**Comments on Mitigated Negative Declaration
for Del Mar Heights School
3.29.2020**

Play Outside™
—DEL MAR—

These comments on the MND for the Heights' School Rebuild Project are submitted by Play Outside Del Mar, a nonprofit public benefit corporation in Del Mar, CA.

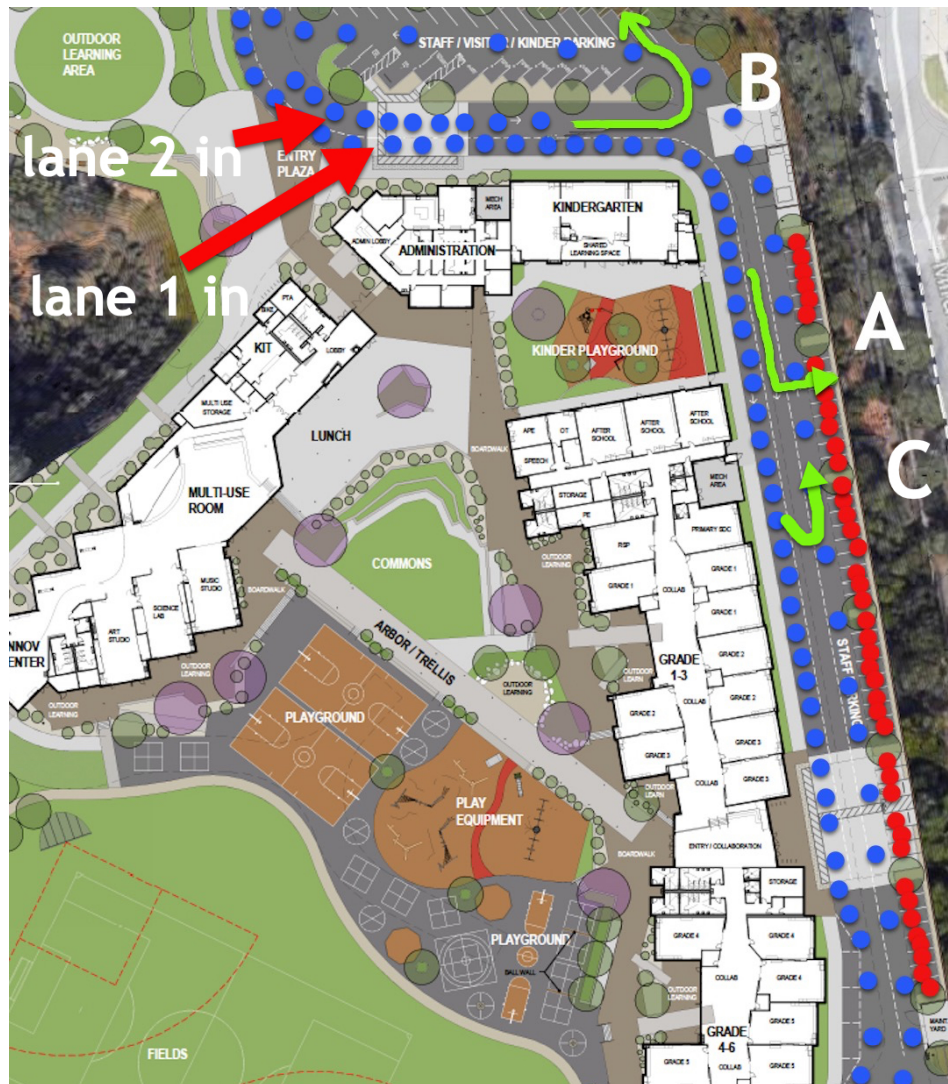
There is no traffic study or even analysis of the critical three lane onsite queue - not for normal operation or for site evacuation and emergencies. A fair analysis shows the bulk of the “problems” identified anecdotally in the MND have not been eliminated, but instead moved onsite into a longer, narrower, more captive channel - and made worse by new opportunities.

The three lane onsite queue combines emergency vehicle access, bi-directional traffic, drop-off, pick-up, merger of two lanes into one at the south turnaround, and forty-five 90° angle parking spots into a width that is seven feet narrower than Boquita Drive. Once you get in, if you follow the rules, you are stuck until you go all the way to the south roundabout and make your way back. Every one of the forty-five staff parking spots pulls out into the single outbound lane of the queue. If you want to park in one of the staff spots, you must wait until you get to the turnaround and head back north - assuming you follow the rules rather than just cut across traffic and grab an open spot.

Here’s the on-site queue, populated with incoming cars in blue at approximately the right density. The red cars arrived earlier and parked. The moving cars are packed tighter on the inbound, as you’d expect; and looser on the outbound, as you’d expect.

You can see the flow interruptions and the safety issues in each of these likely approaches. Because of the length of the long part of the queue, it seems very likely that a number of cars will stack-up at point B trying to make that left turn into the Visitor Lot to get out - much **more** likely than waiting for the 30-50 cars in front of them to go all the way to the end of the queue and 180 at the south end and return back and out of the site.

Above are but a few ***fair arguments*** that the traffic queue will present unanticipated problems that worsen (rather than improve) safety and worsen (rather than improve) traffic flow. It does not matter for an MND, as noted above, that a contrary argument can be made. An MND is improper in this situation and an EIR with a proper traffic analysis of the queue must be done.

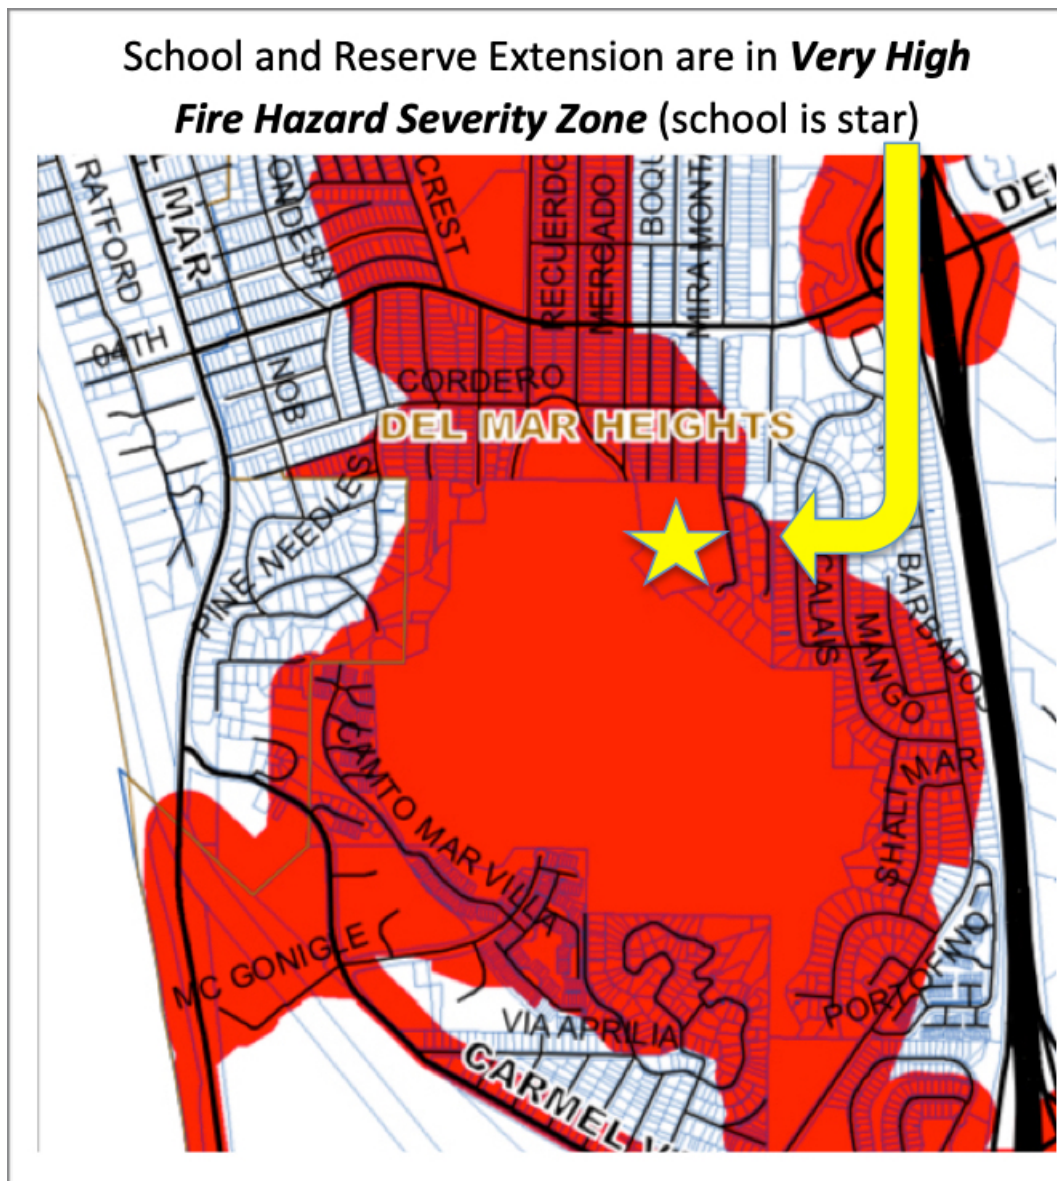
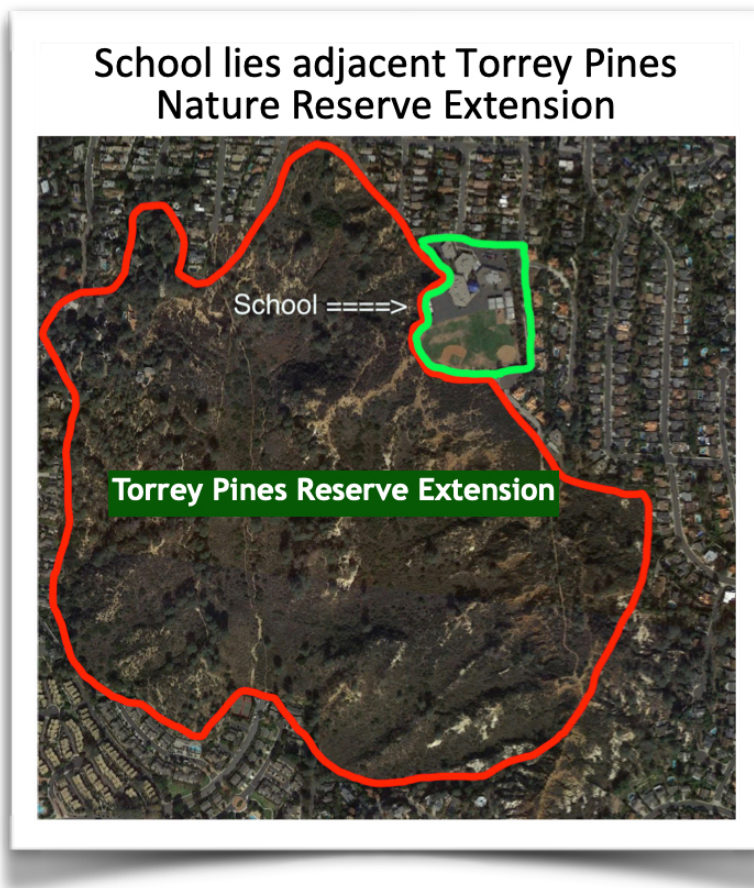
In response, the MND says: “The project site is relatively flat and is in a predominantly urbanized environment.”

This is again false. We show below that the DMUSD property itself includes dramatic and substantial drop-off areas on the west side - inside the defensible space area - with a slope of at least 38° and ranging from 20-50 feet drop. But the question by its terms is not limited to the property boundaries and the property technically owned by DMUSD, so the full truth would have included the Reserve that is adjacent, which provides slope, fuel, and the “other factors” (also discussed by us below).

The answer just ignores the pointed questions about “prevailing winds,” “other factors,” and “uncontrolled spread of a wildfire” entirely.

The answer (to a wildfire question!) says the project in a “substantially urban environment” when it is surrounded more than 180° by a Reserve with 197 acres of dry fuel on a substantial southern slope.

West emergency fire access road - the only way for emergency vehicles to get to the site core - runs tight along the west canyon rim, 25 feet from possible canyon fire

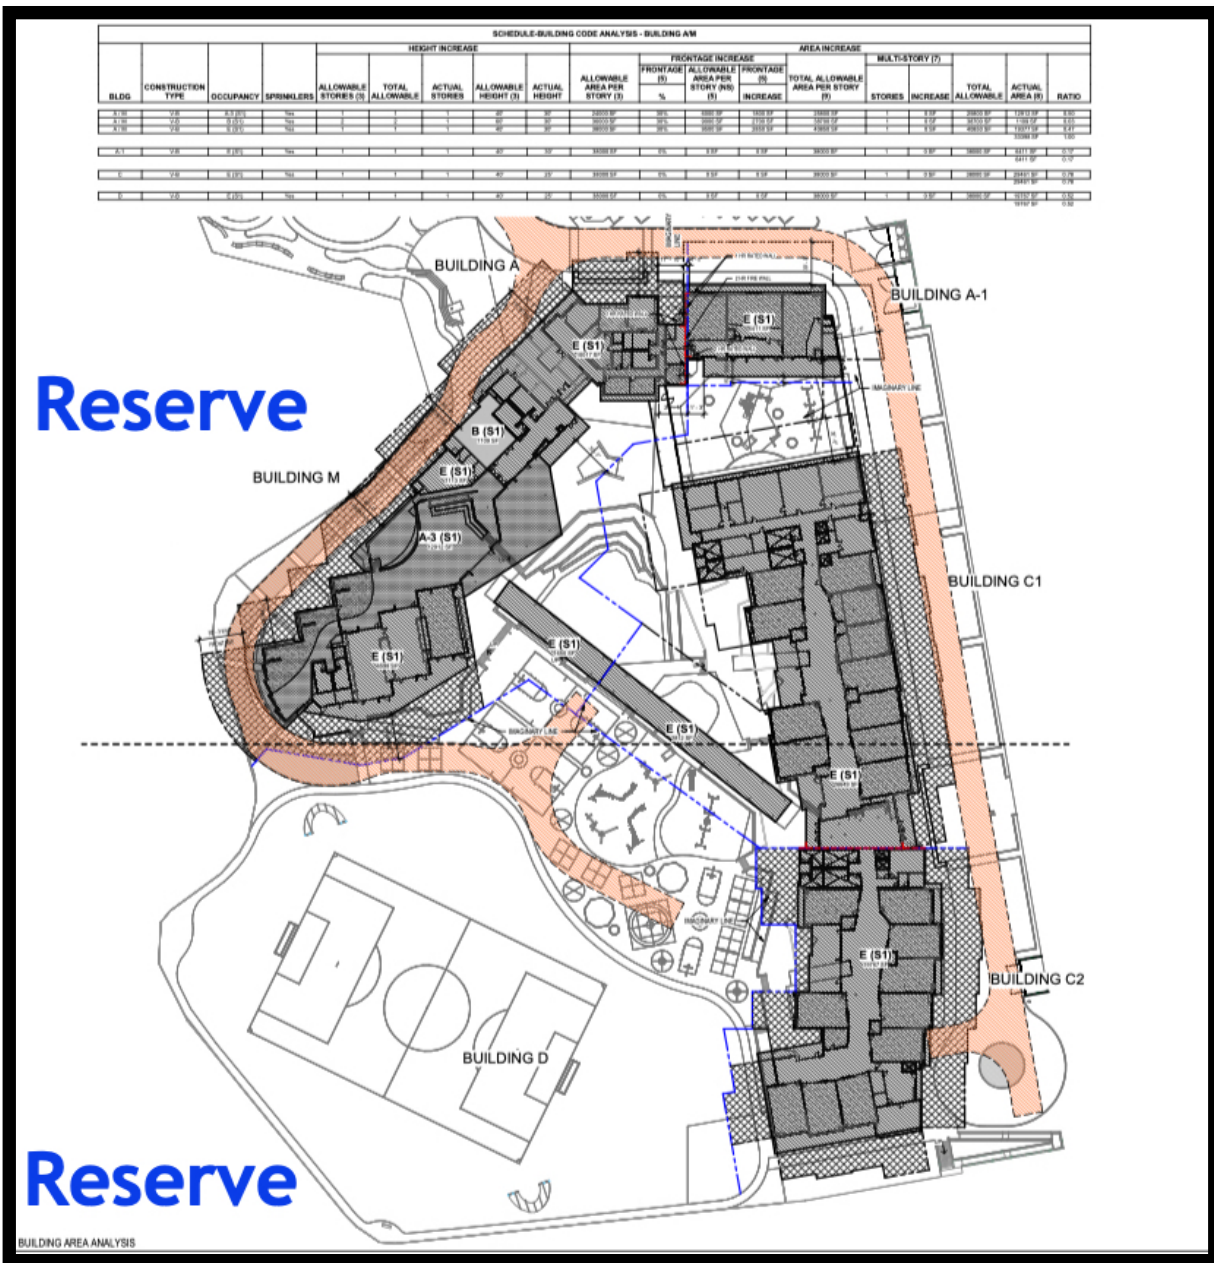
In the photo above, you can see the path a fire truck takes to gain site access today. Entry on Boquita, turn east and then move across the blacktop to the west - full site access and within 150' of every inch of every building, as required for non-sprinklered buildings.

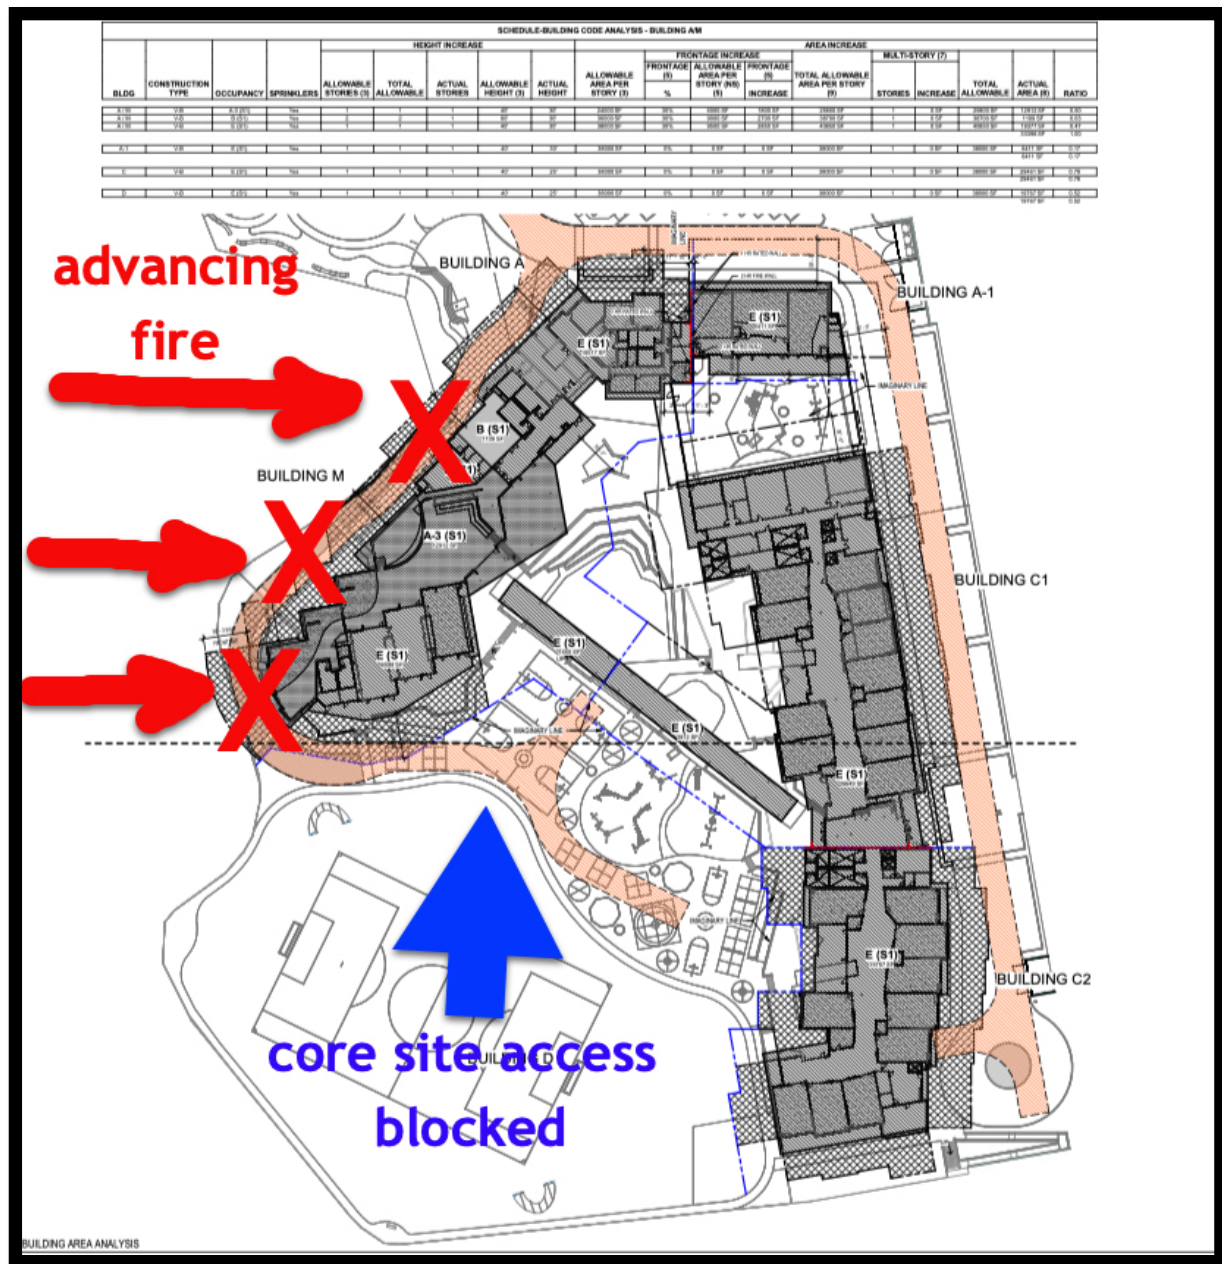
The image above is a page from the construction plans for the new school design. The fire access roads are orange. There are some significant changes between today and this plan.

But suppose there is an Reserve Extension fire that is hot on the rim of the canyon on the west of the school site, or has already advanced onto the west buildings. As shown in earlier sections, conditions and topology make that more than a theoretical possibility.

If that happens **before** emergency vehicles get to the site, they might be blocked from accessing the school site core by the west road - which is the only way to get to the core. If it happens **after** emergency vehicles get to the site and make it to the core of the facilities, then they might not be able to get out - emergency personnel or victims could be stuck. The next figure illustrates this potential situation.

Location of 30 foot high “Innovation Center” shrinks defensible fire space to less than 20 feet on the canyon rim

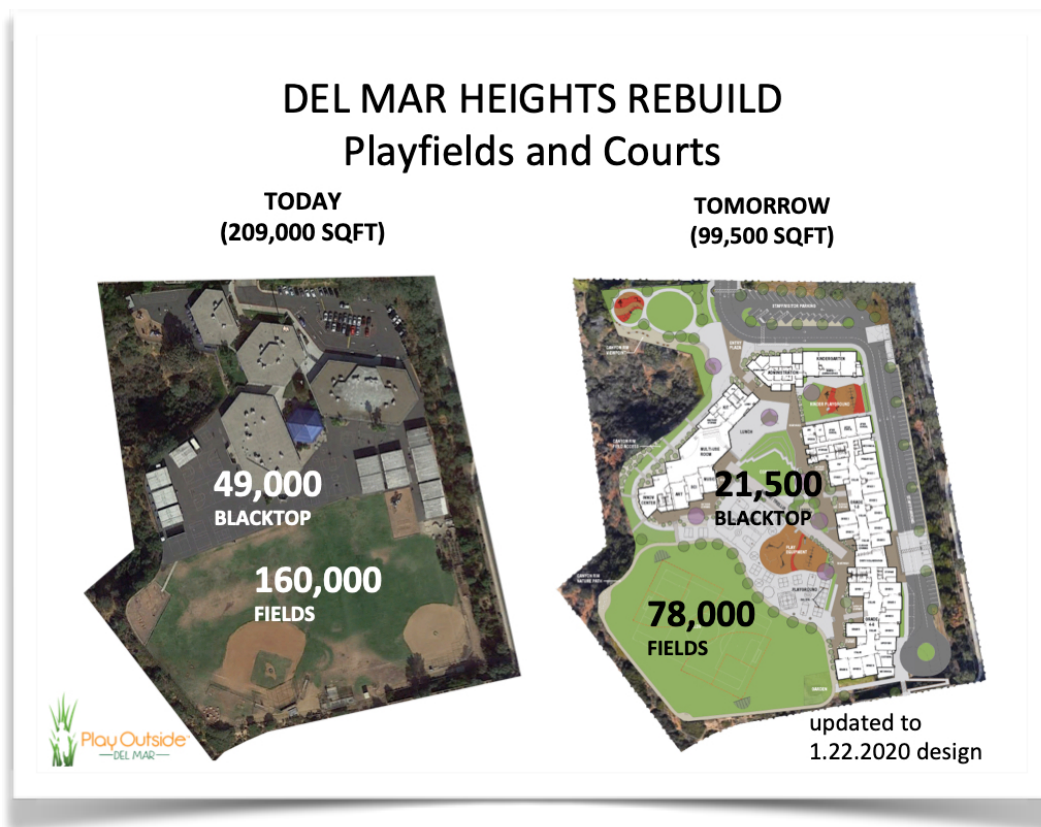
Let's look at the defensible space area in the proposed new school design - with particular focus on the area exposed to a potential wildfire from the reserve. The yellow prongs (which we have added) show where 100' from the building walls ends, approximately. As you can see, there's a problem - it's far out into the heavily wooded areas adjacent the school, down the 38% slope we mentioned earlier, and then some.⁴⁷ The construction plans on file with the Division of State Architect acknowledge these areas are either "dense trees" or "dense brush."⁴⁸

The 100' mark actually extends even **further** out than shown above - in some areas 20' further than shown - because the detailed construction plans show the building awnings extend further toward the wooded areas.

the steep drop into the heavily wooded canyons. We are told by fire experts that the steep angle of the wooded slope with westerly winds leading to a tall building is not the best situation, to put it generously.

By pushing the building as close as possible to the westernmost point, to increase views and enlarge facilities, the school district has created a disturbing predicament that is not disclosed openly in the proposed environmental MND.
